ADDENDUM NO.	1	DATED	8/17/2015	ADDENDUM NO.		DATED	
ADDENDUM NO		DATED		ADDENDUM NO.		DATED

Number	Description
1	Revised Table of Contents; Add NTB Nos. 5786 & 5787; SP 907-622-7, replaces SP 907-622-6; Revised BidItems; Revised or Added Plan Sht. Nos. 2, 4-11, 13-16, 22-25, 27-31, 33, 34, 38, 46-49, 85, 86, 88, 93-95, 212, 213, 220-223, 249-251, 256-259, 262, 263, 319, 320, 331-333, 2001, 2031, 6315, 6316, & 6324; Amendment EBS Download Required.

PROJECT: STP-0056-01(075) / 104101301 - Rankin

Construction necessary to Add 2 Lanes to SR 25 from SR 475 to Grants Ferry Road, known as Federal Aid Project No. STP-0056-01(075) / 104101301 in Rankin County.

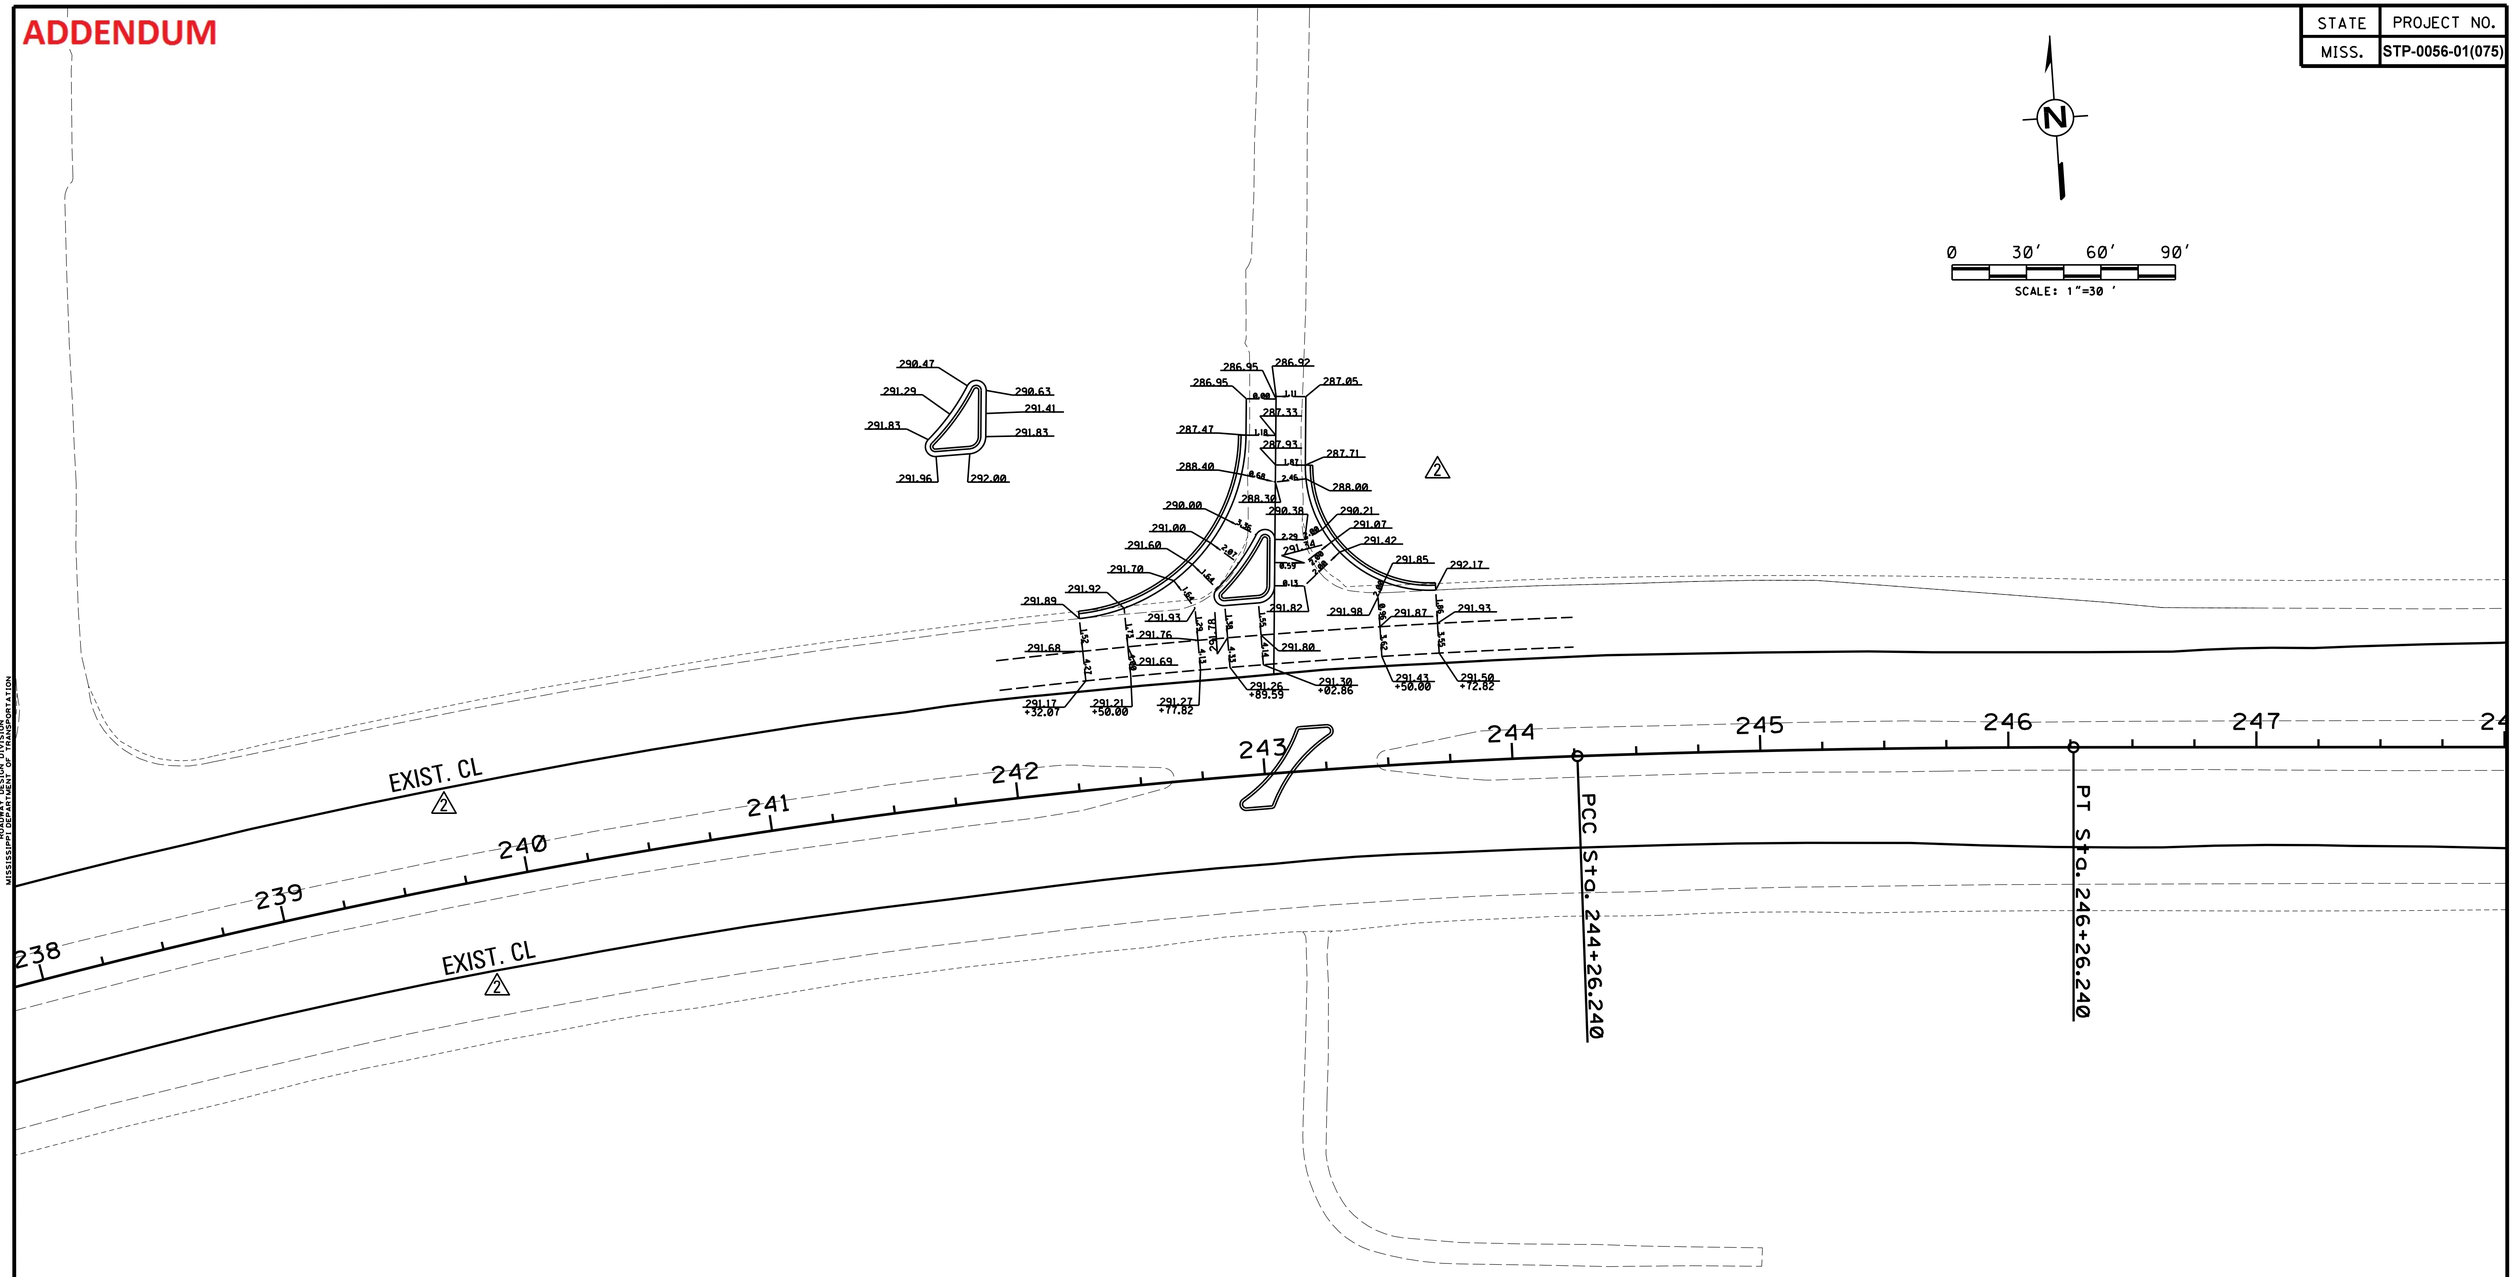
DATE	REVISION	BY
8-12-15	ADDED FORM GRADES & EX. CL	JT
7-20-15	ADDED SHEET	JT

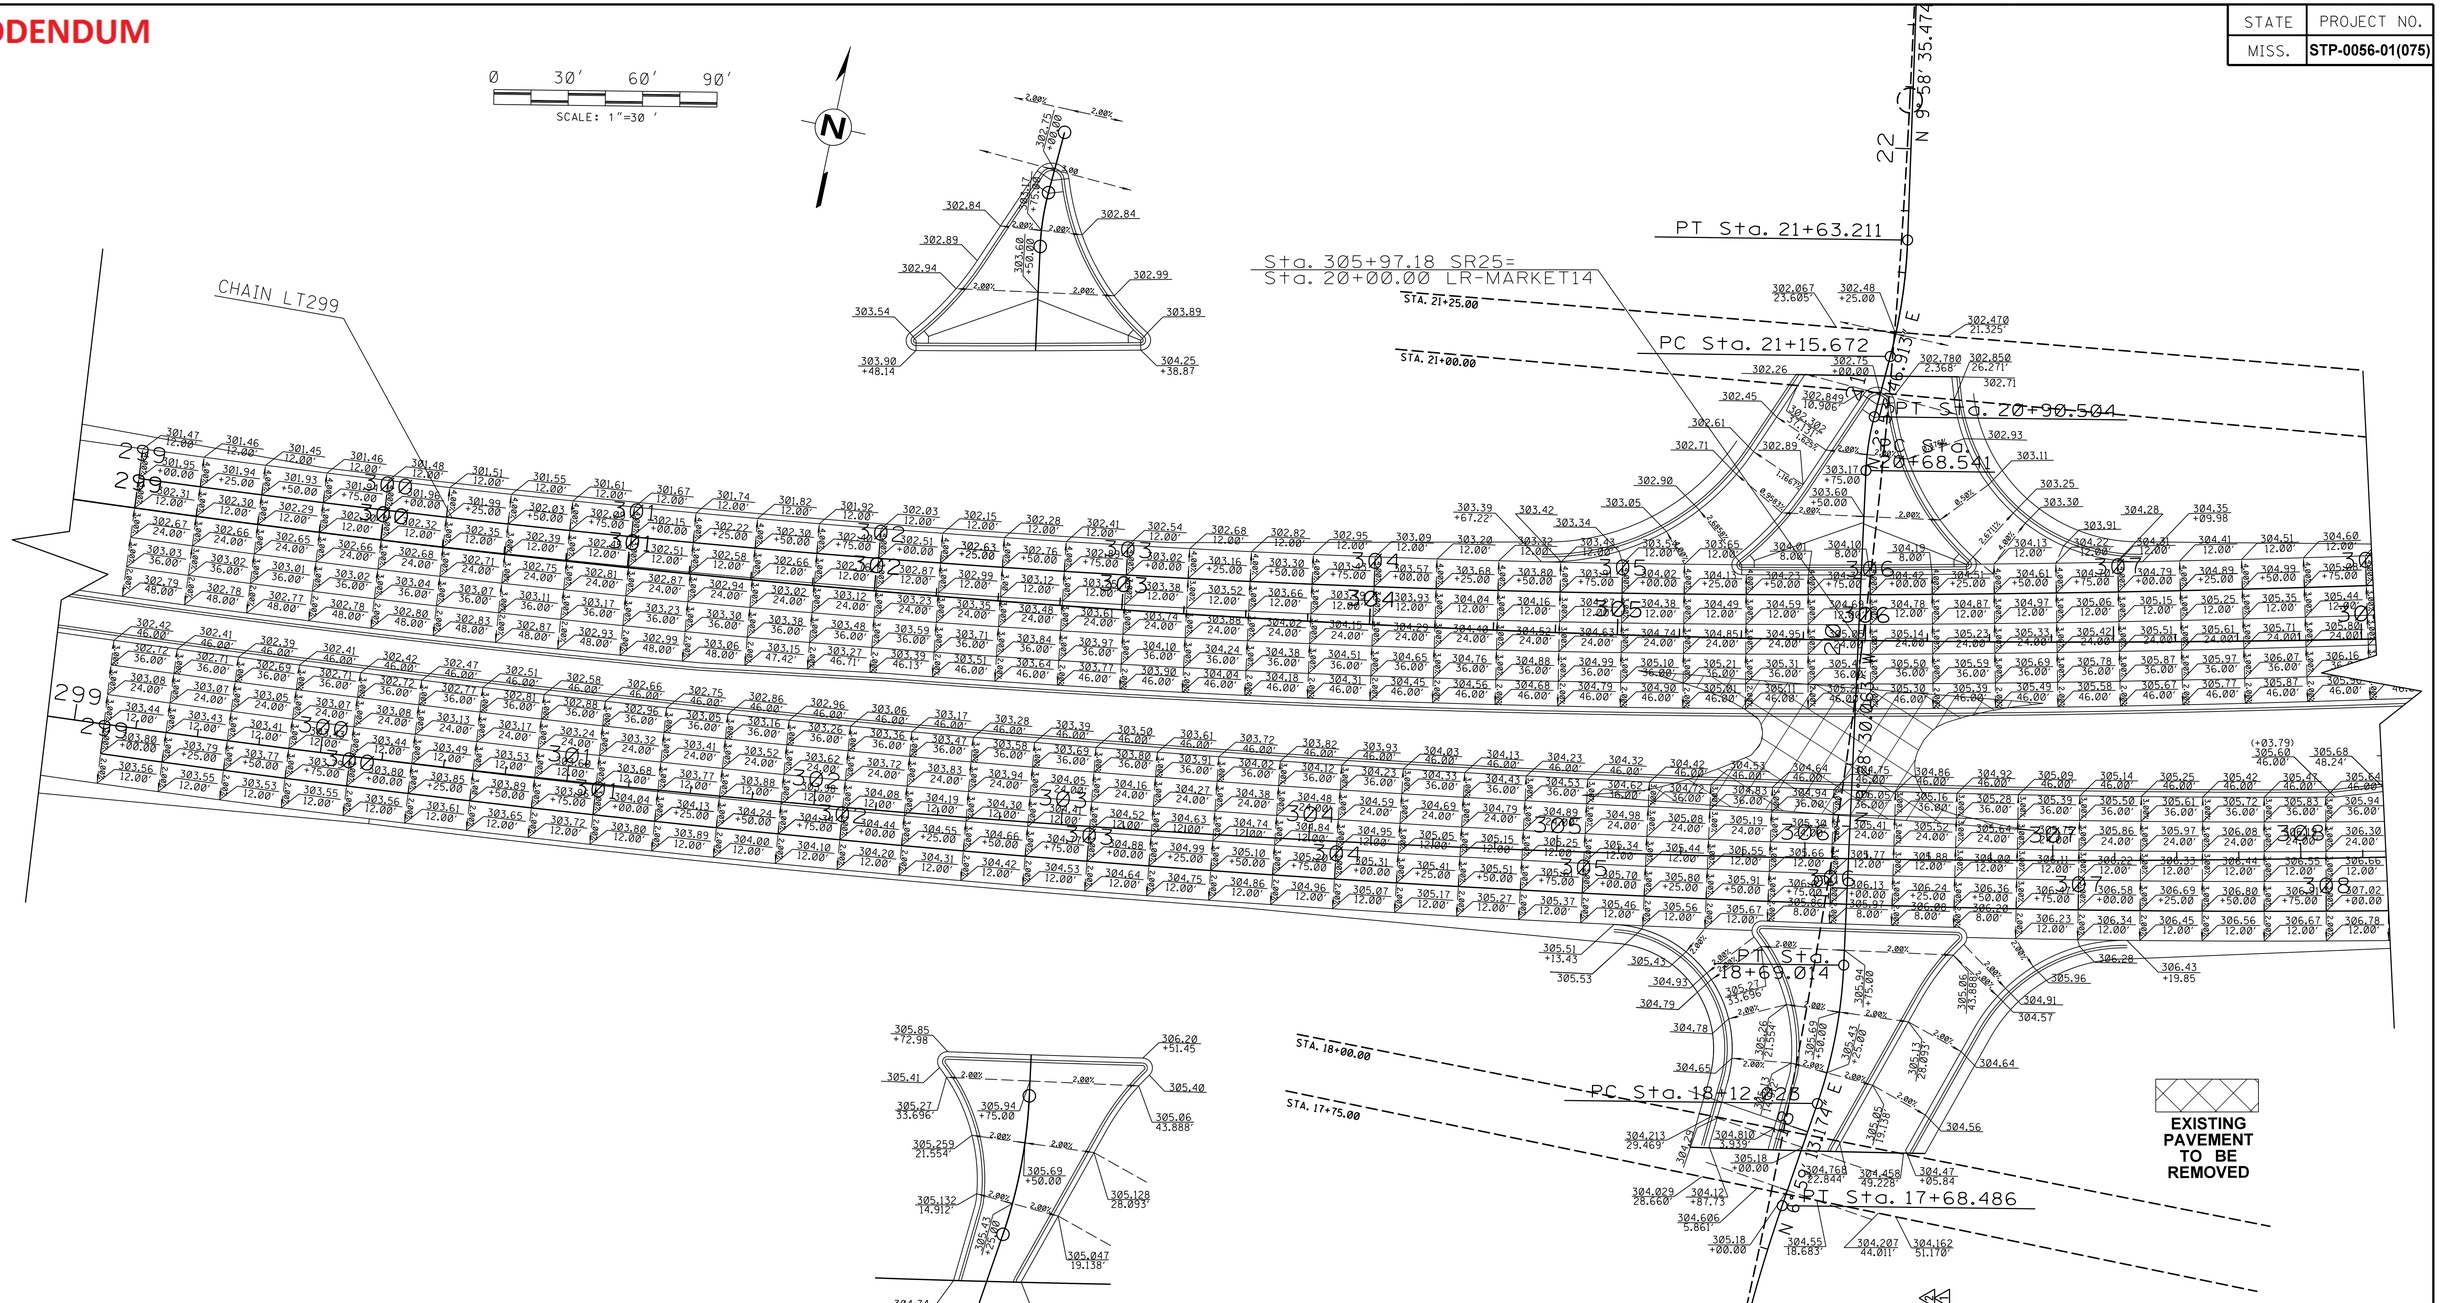
BY	DATE	REVISION
JT	8-12-15	REVISED FORM GRADES
JT	7-20-15	ADDED SHEET

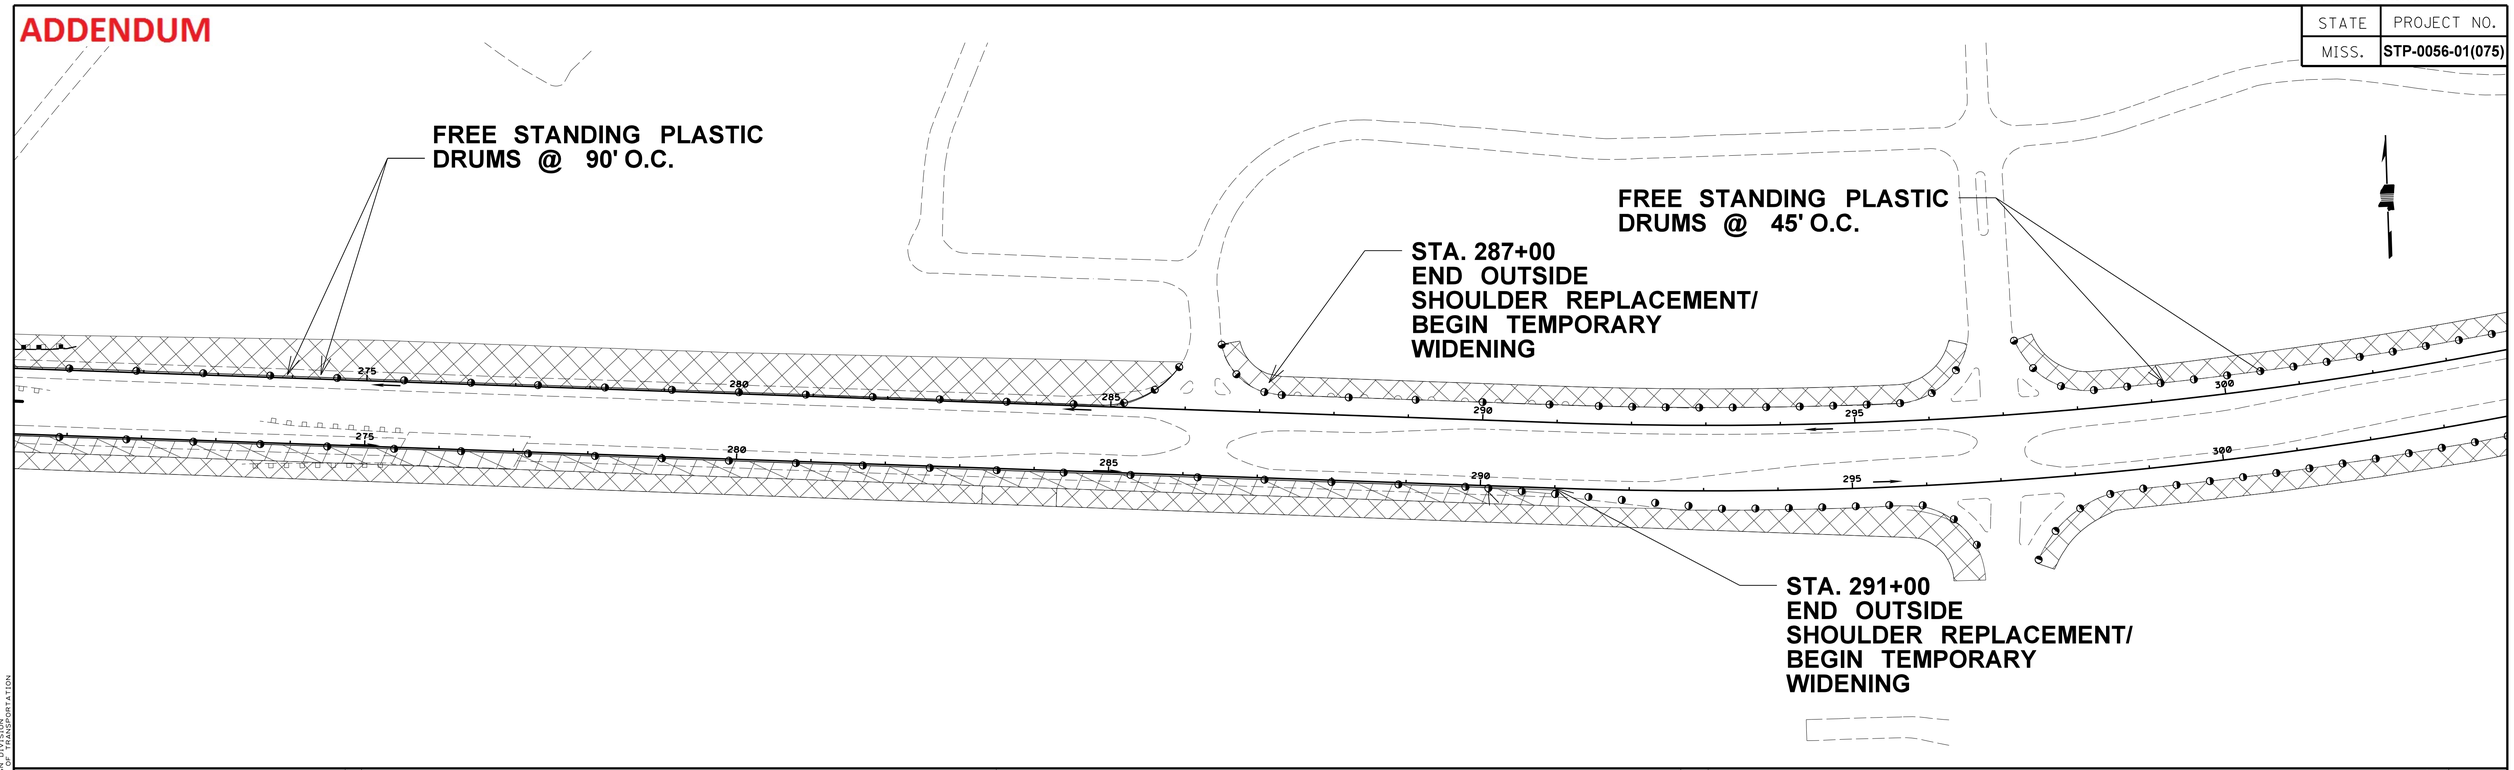
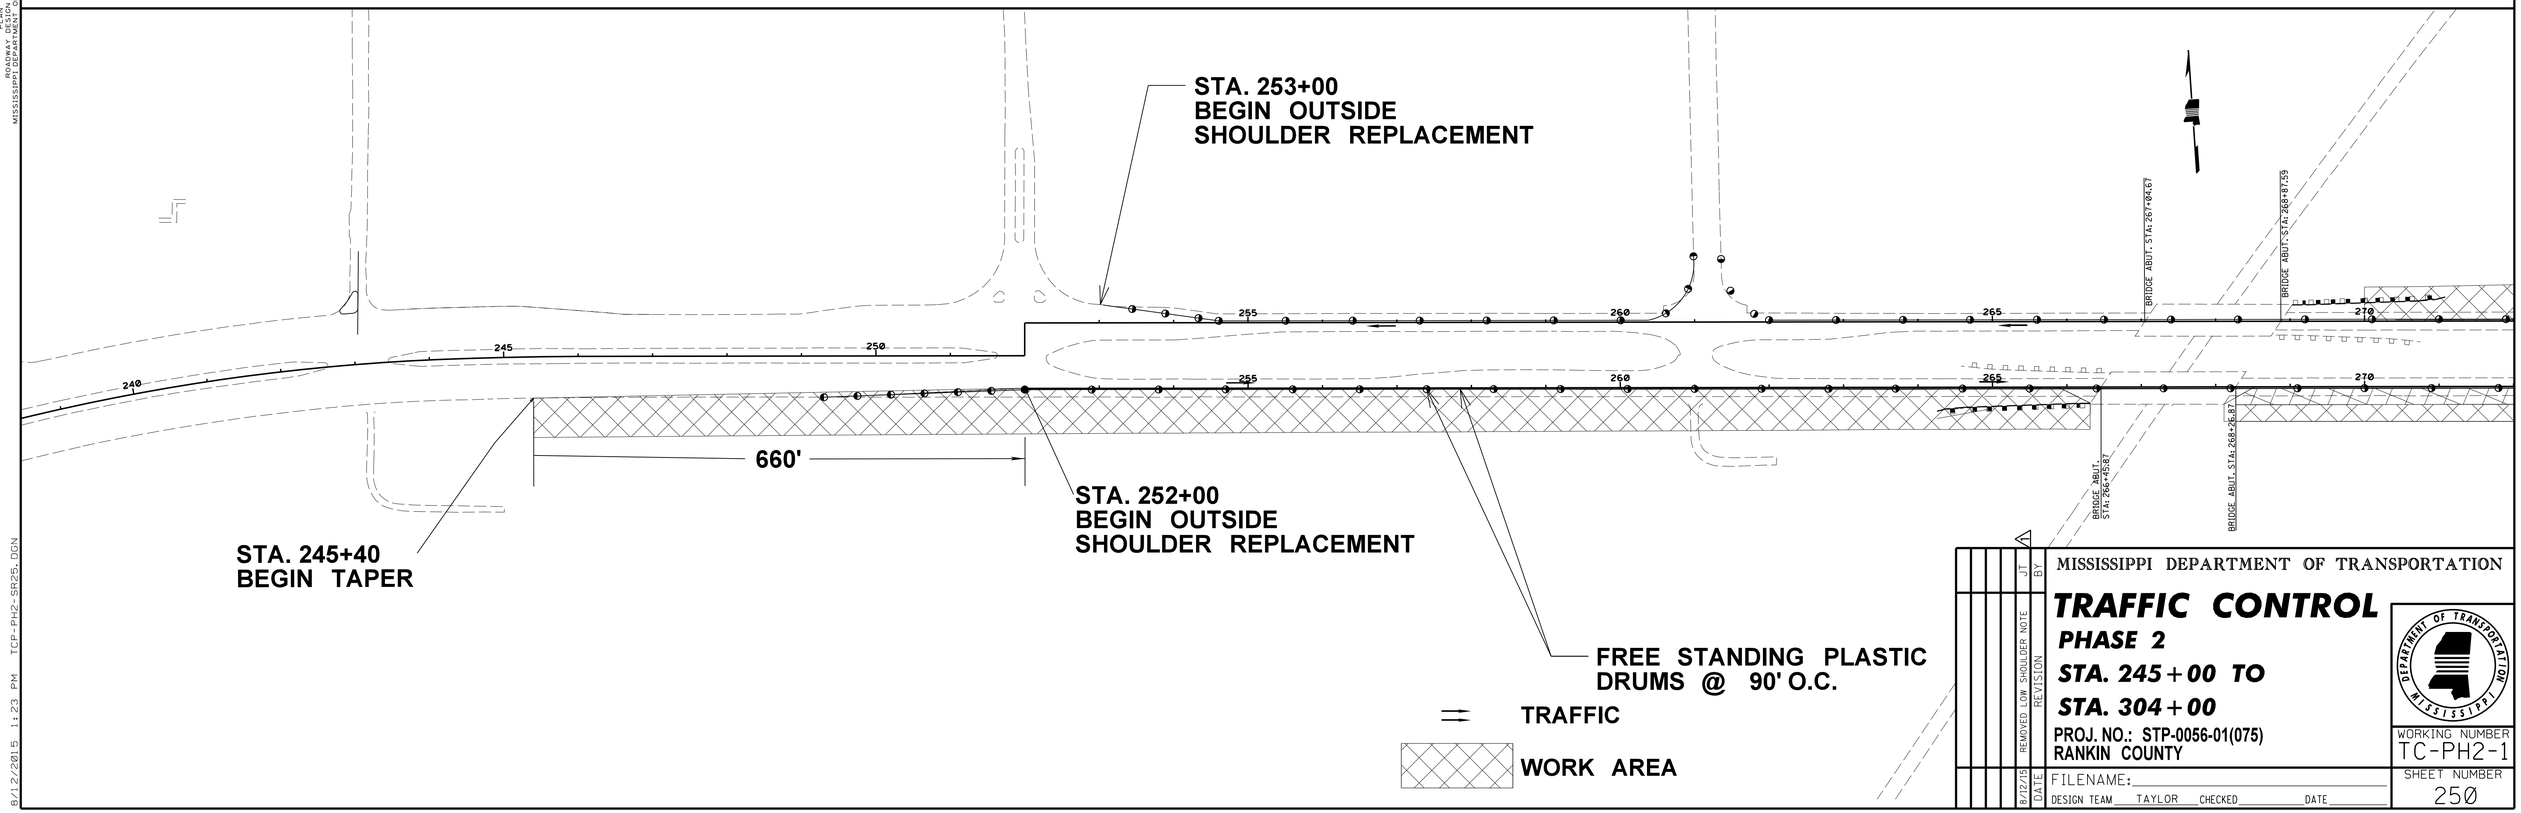
DATE	REVISION	BY
8/12/15	REMOVED LOW SHOULDER NOTE	JT
